## TECHNICAL SERVICE BULLETIN

### 4WD - Grinding/Rubbing Noise Under Acceleration From Floor Pan/Underbody Area

**22-2161**

<b>Ford</b>
2021-2022 Bronco Sport
2020-2022 Escape
2022 Maverick
<b>Lincoln</b>
2020-2022 Corsair

Figure 1

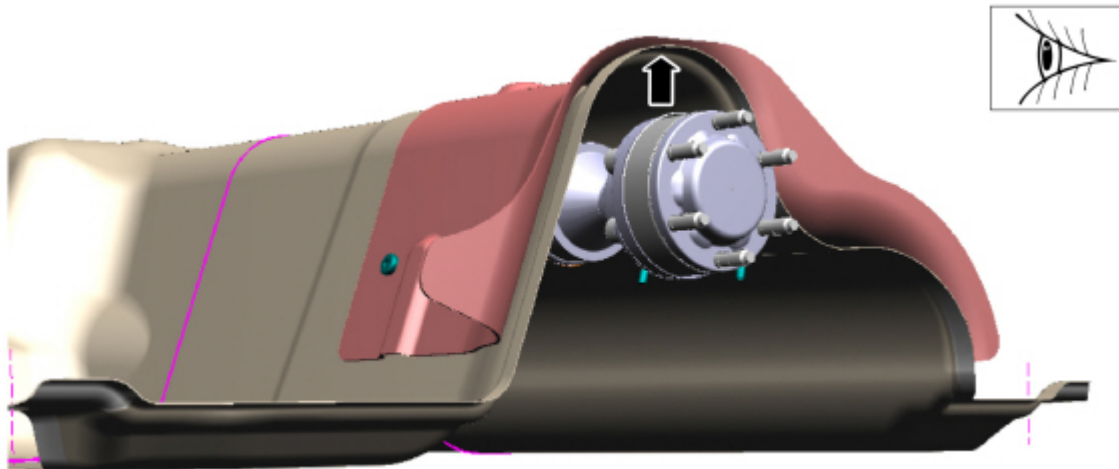
1. Visually inspect the fuel tank heat shield to see if there are witness marks from where the driveshaft has made contact with the fuel tank heat shield.
2. Are there signs of witness marks from the driveshaft contacting the fuel tank heat shield? (Figure 1)
  - (1). Yes - proceed to Step 3.
  - (2). No - this article does not apply. Refer to Workshop Manual (WSM), Section 100-04 for normal diagnostics.

Figure 2

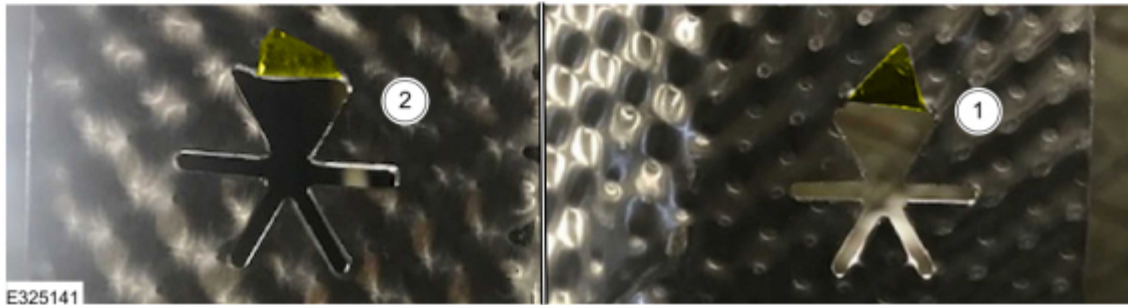
3. Remove the right rear and left front fuel tank heat shield retainer nuts. Refer to WSM, Section 310-01A.
4. Using pliers or equivalent, modify the heat shield attachment star-shaped openings.
  - (1). Bend the tab closest to the front of the vehicle downward and flatten the tab against the bottom of the heat shield. (Figure 2)

**NOTE: Once bent, the tabs should be pointing down and away from the underside of the vehicle. (Figure 2)**

Figure 3

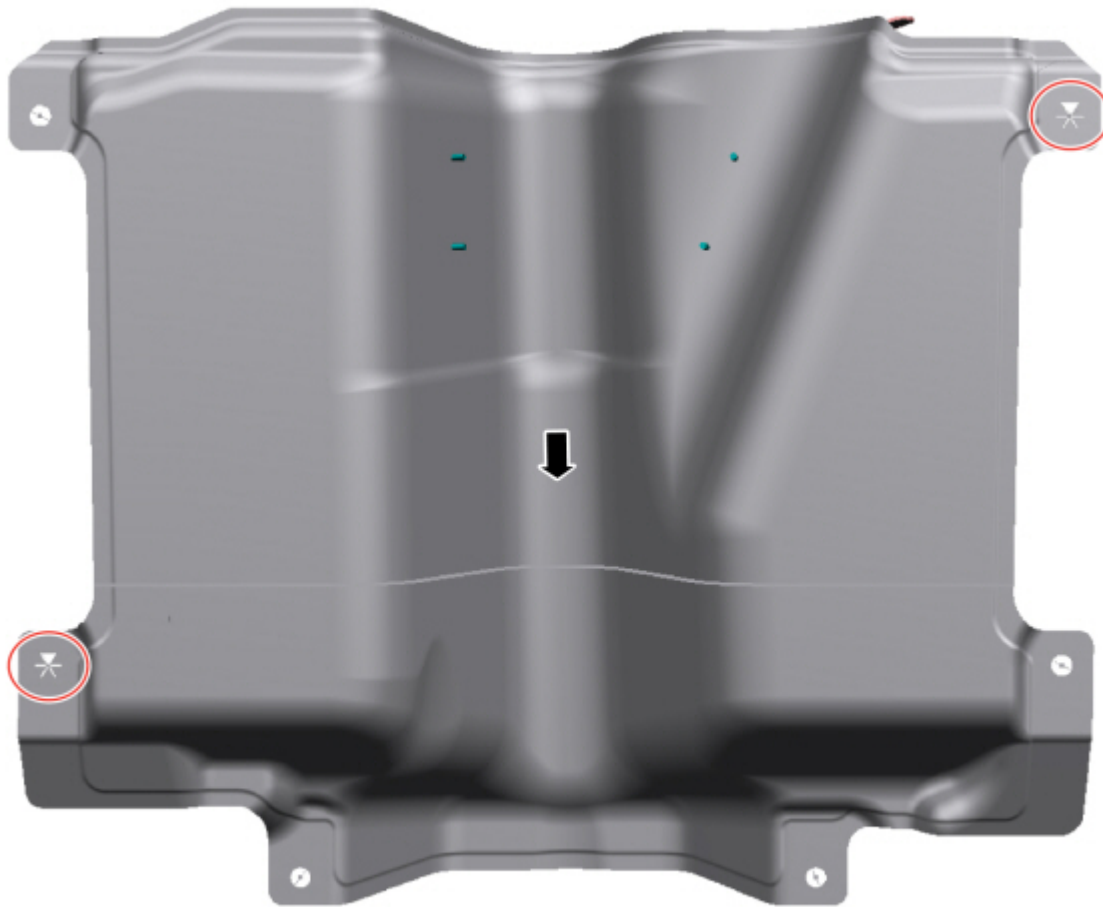
**6.** Reposition the heat shield toward the front of the vehicle. (Figure 3)
